# SAN FRANCISCO PLANNING DEPARTMENT

**DATE:** November 9, 2011  
**TO:** Historic Preservation Commission  
**FROM:** Rich Sucre, Historic Preservation Technical Specialist, (415) 575-9108  
**REVIEWED BY:** Tim Frye, Preservation Coordinator, (415) 575-6822  
**RE:** **Review and Comment**  
**850-870 Brannan Street**  
**Case No. 2011.0583B**

**ELEVATION - BRANNAN STREET**  
SCALE: 1/32" = 1'-0"

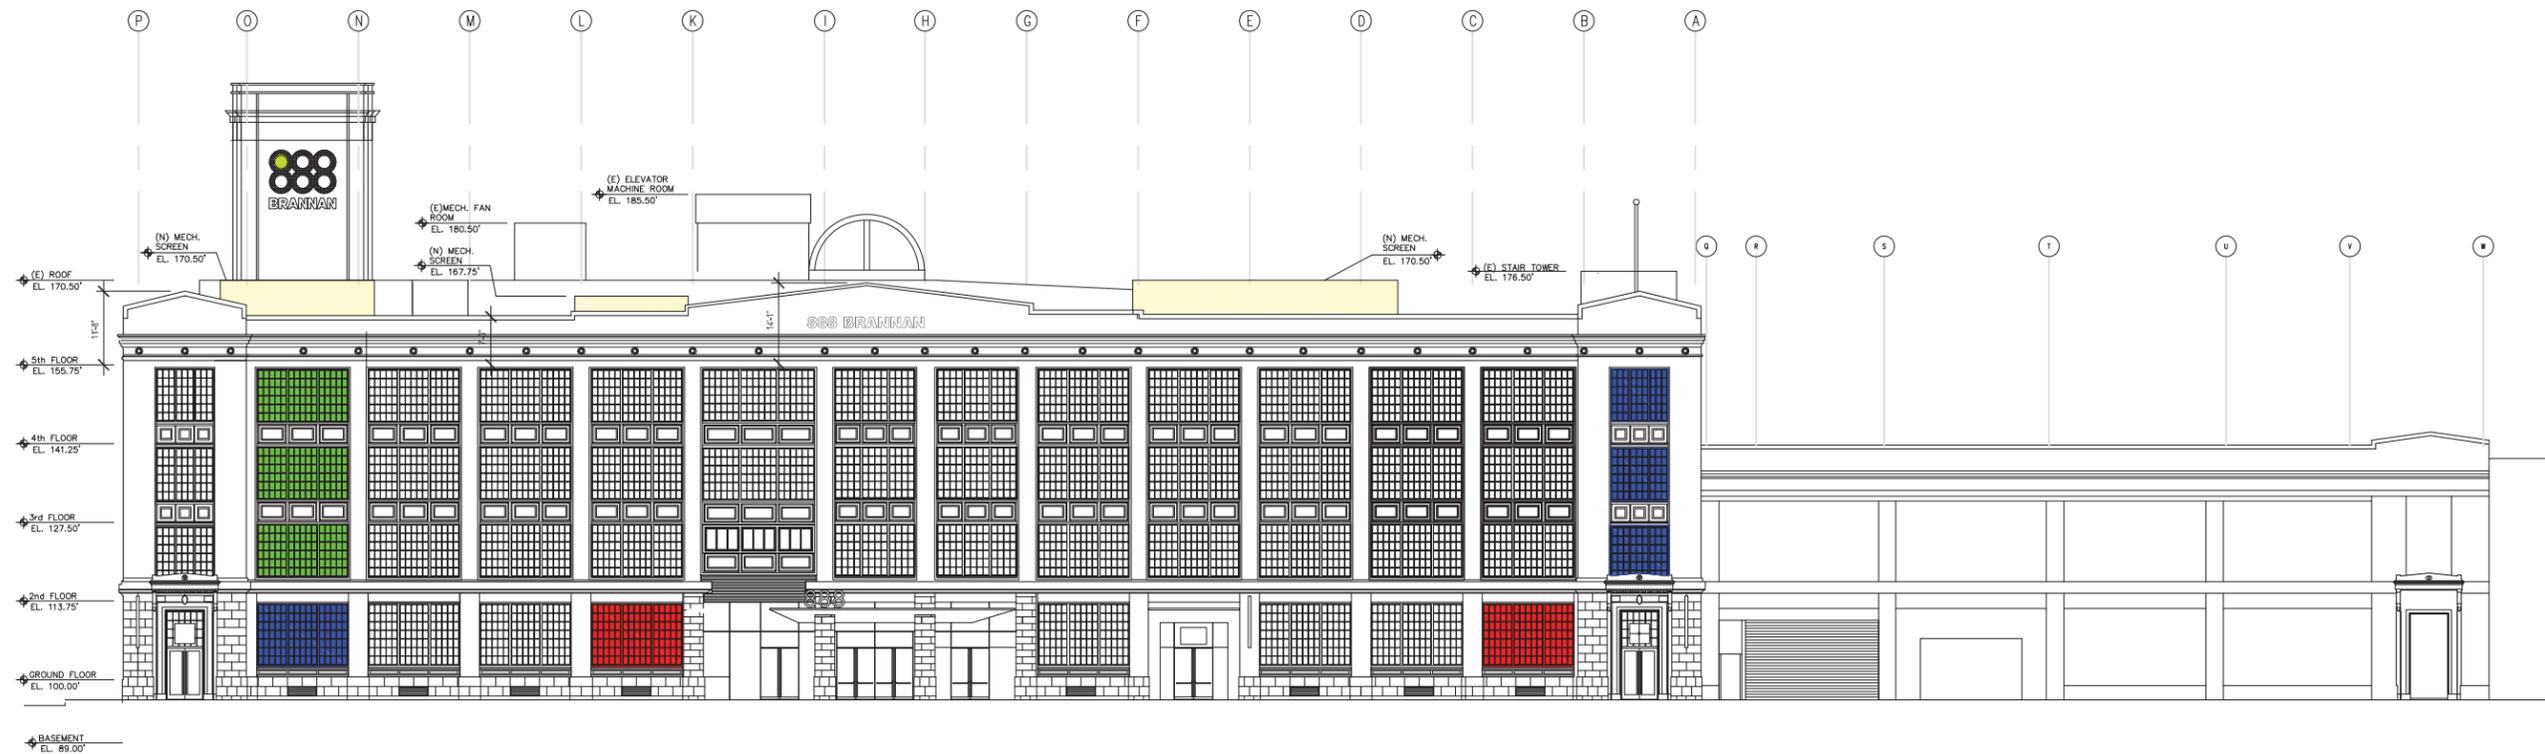
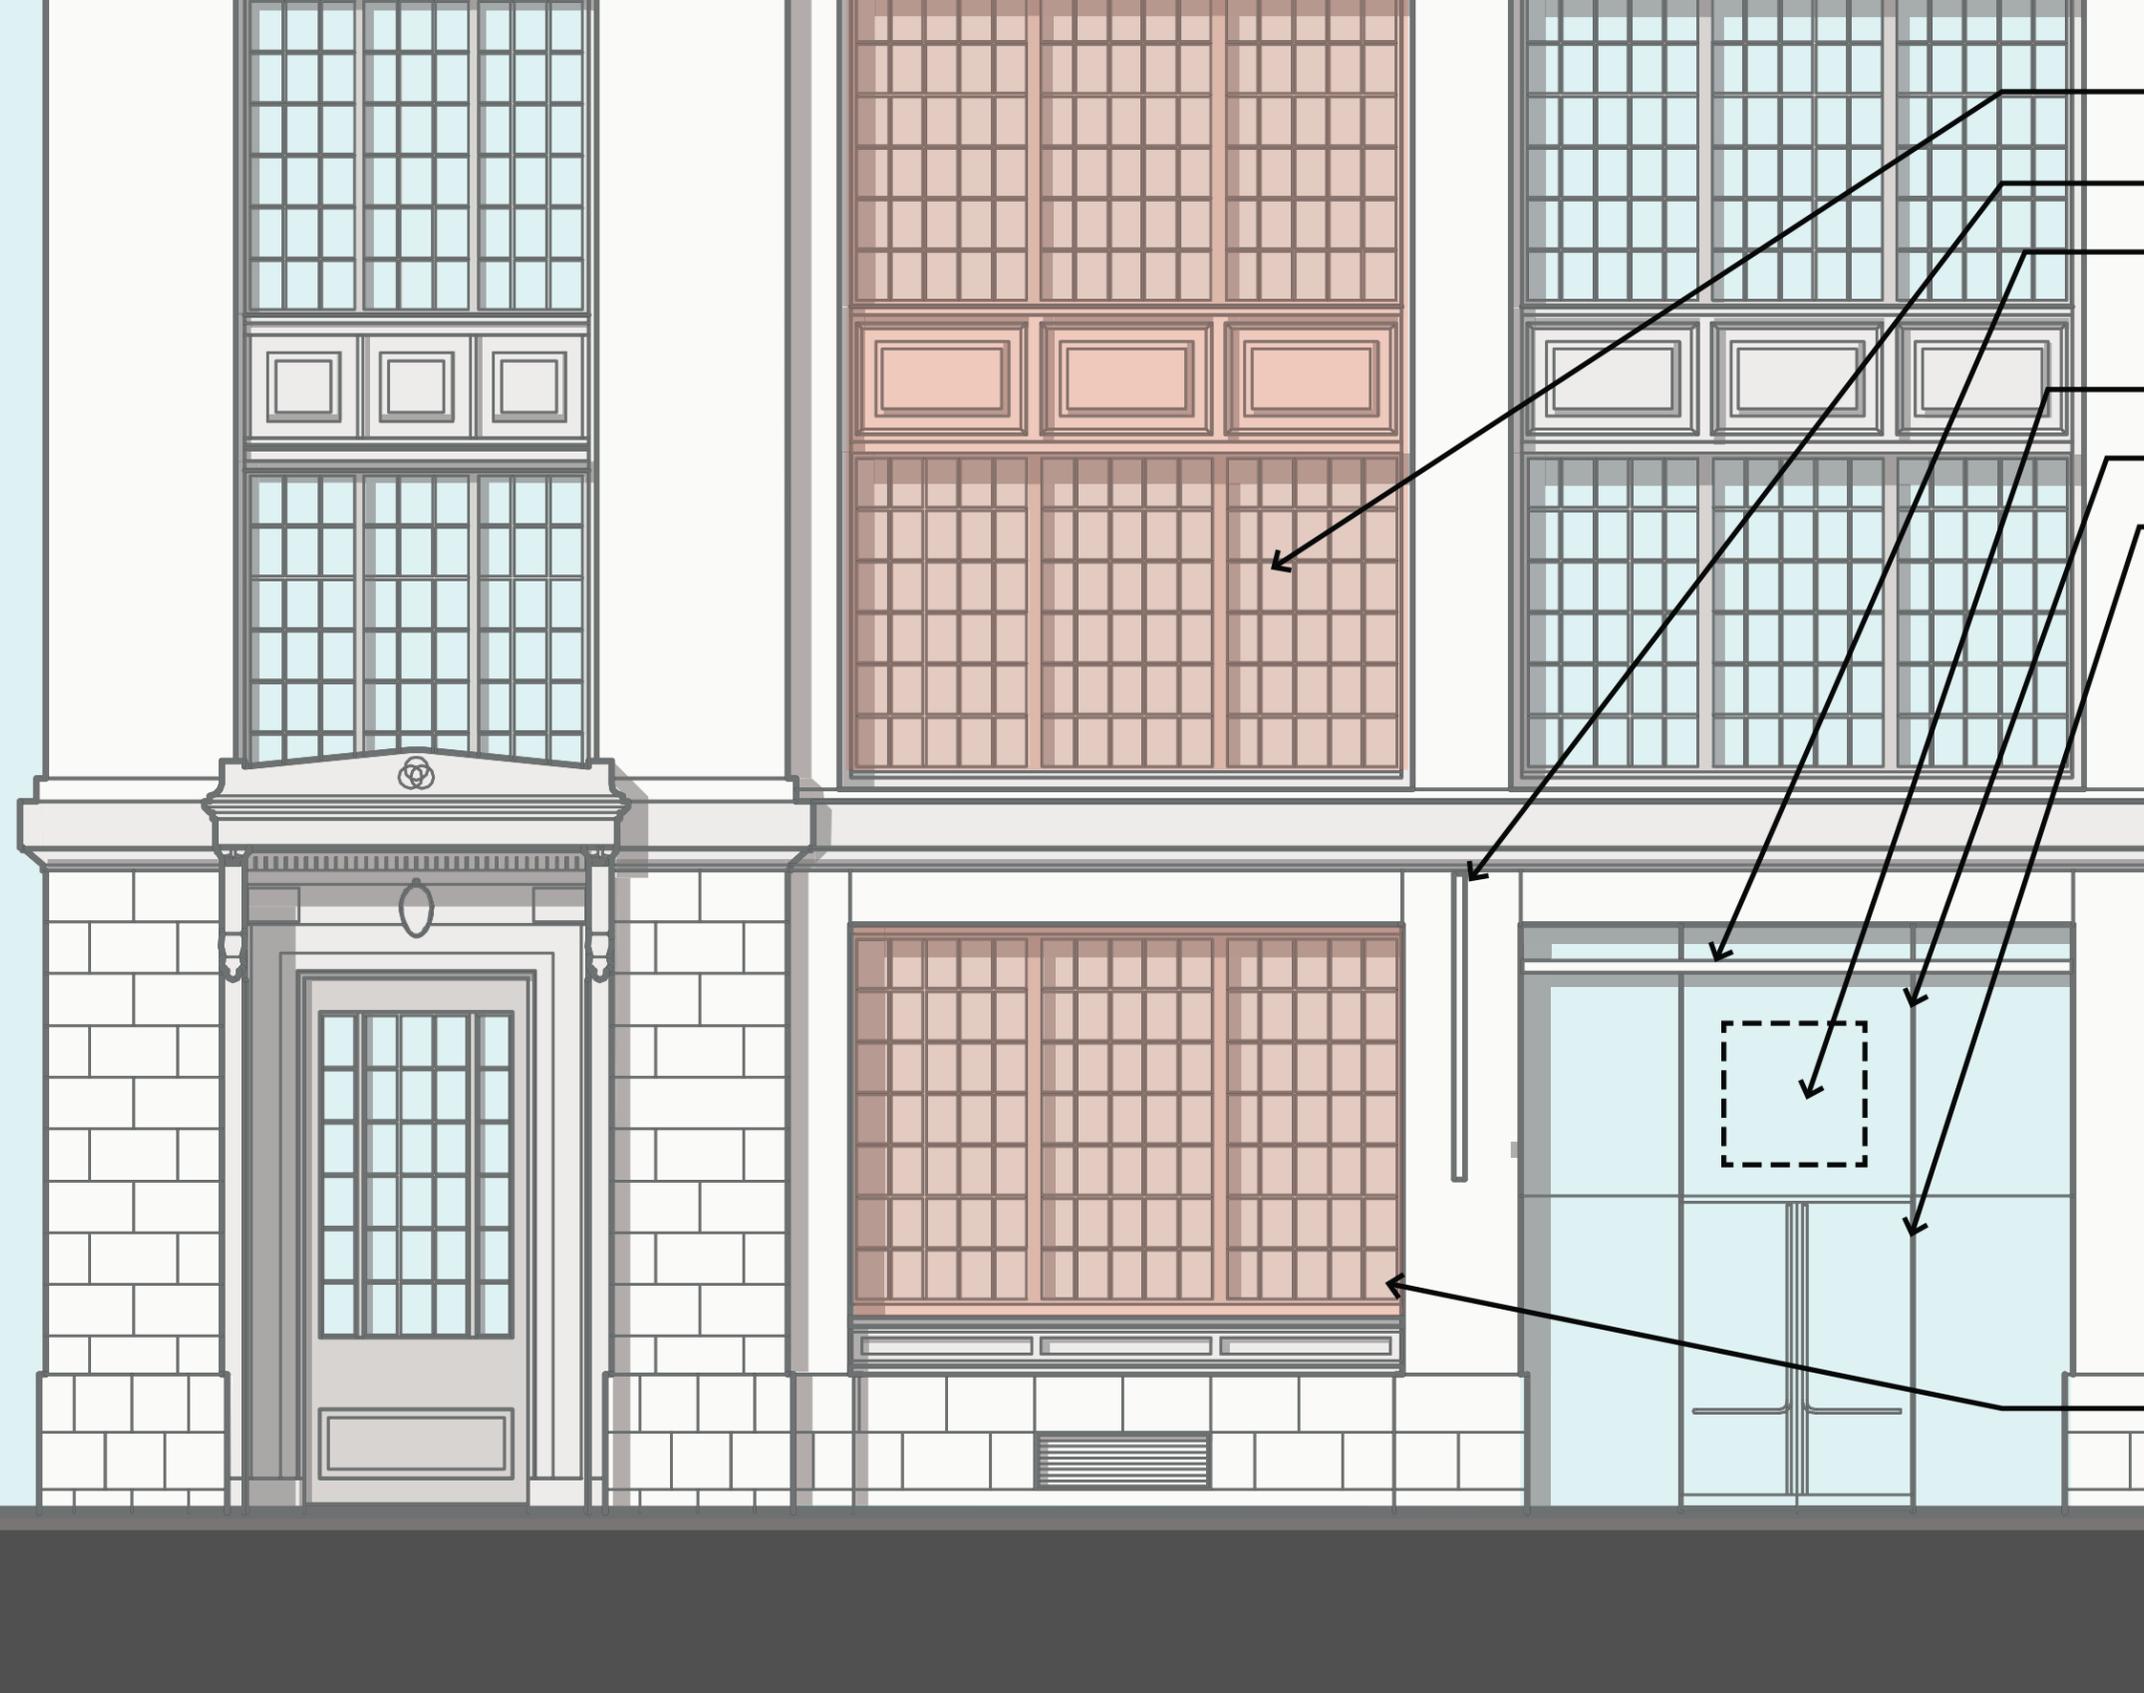
- The project proposes to retain and repair original steel-frame windows remaining at the ground floor of the building (as noted in Sheet A4.0, and Section 080152.93 – Historic Treatment of Steel Windows). These windows will be stripped of paint and repaired and repainted. Existing painted/translucent, corrugated glazing will be replaced with clear glass (or micro rib corrugated glass for portions of the corner towers) and deteriorated concrete around the openings will be repaired. Retention and repair of these windows, which are in somewhat better condition than windows on upper floors, will preserve original materials at that portion of the building most accessible to the public.
